LLOYD'S REGISTER OF SHIPPING

Ship's Name "OTIS" EX "WESTBRIS" Official No.

Memorandum of alterations reported since ship was surveyed for assignment of Load Lines in DECEMBER 1950 AT KIEL

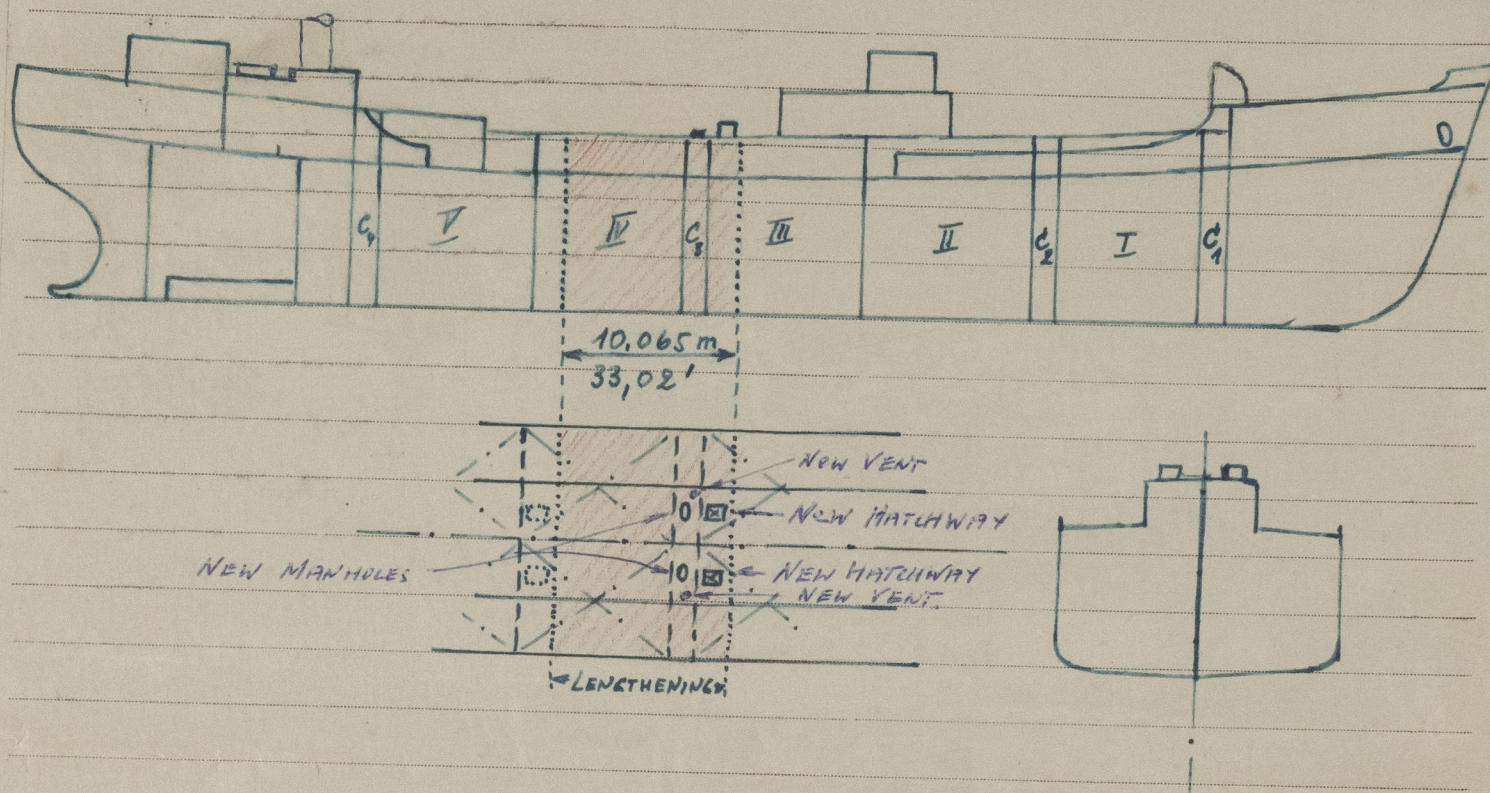
ALTERATIONS NOW EFFECTED: -

- 1.) Lengthening of the hull by 10.065 mm - 33,02'
- 2.) Fitting of 2 additional oil hatches for No.III cargo oil tanks (1 p.s., 1 s.s.) of same dimensions, (see above sketch) coamings, covers and closing arrangements as the existing 8 cargo oil hatchways, viz.: 1140 x 760 mm, coaming 200 x 12 mm with steel hatch covers of 12,5 mm thickness and hemp packing.
- 3.) Fitting of 2 main holes and doors for access to the now installed No.3 cofferdam, 400 x 600 mm, coaming 250 x 10 mm with steel hatch covers and hemp packing.
- 4.) Fitting of 2 additional ventilators for the now installed No.3 cofferdam of substantial construction coaming 760 x 8 mm, E.W. to deck plating and closed by steel covers and canvas covers.
